CLOVERLEAF SUBDIVISION

PRELIMINARY PLAN

PRELIMINARY PLAN

DATE	BY	DESCRIPTION:
9/11/2020	JBS	PER COUNTY COMMENTS
11/6/2020	JBS	PER COUNTY COMMENTS

COVER

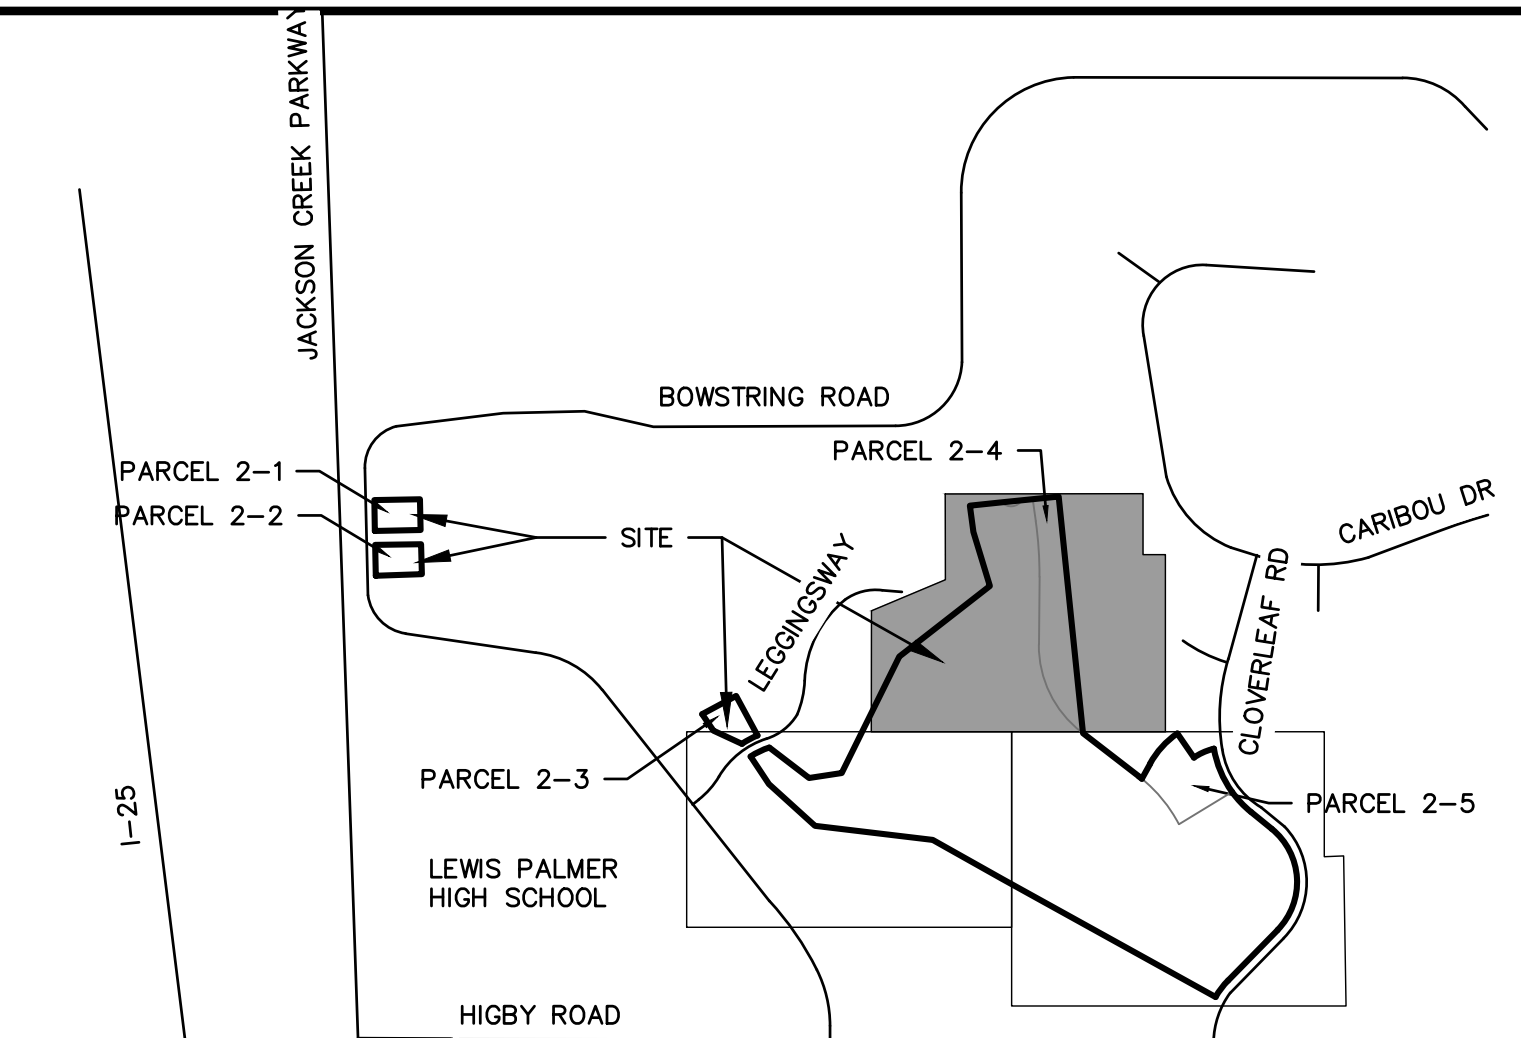
PARCEL 2 What is this legal description for? It appears that what is referenced as Parcel 2 is included in the legal description above for parcel 1 since it lists both parcel numbers.

Update per CGS recent Comments. Make sure to include all the impacted lots as well.

- Trails within the open space areas will be constructed as 5-foot breeze trails. All trails within the open space areas will be 5-foot breeze trails. what is a breeze trail?
